MODBAR TECHNICAL BULLETIN #43

New solenoid valve for Modbar Steam

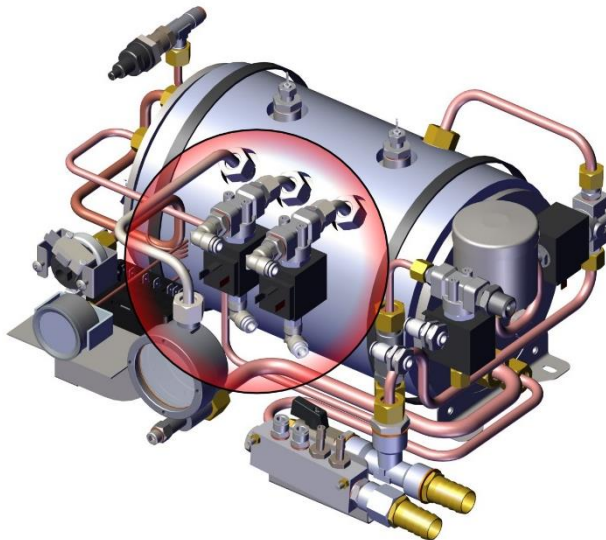
We are very pleased to introduce a **new steam activation solenoid valve assembly**.

The new valve has been fully re-engineered and presents multiple improvements, including a full AISI 316L steel body, an upgraded plunger seat, and 4.5mm steam passage hole. Overall, the performance and stress resistance have now been significantly enhanced.

All machines starting from Serial Number **MB007340** now feature the new valves.

The new valve assembly is available as part number **B.3.008**. The old valve assembly, B.2.030.01, is no longer available.
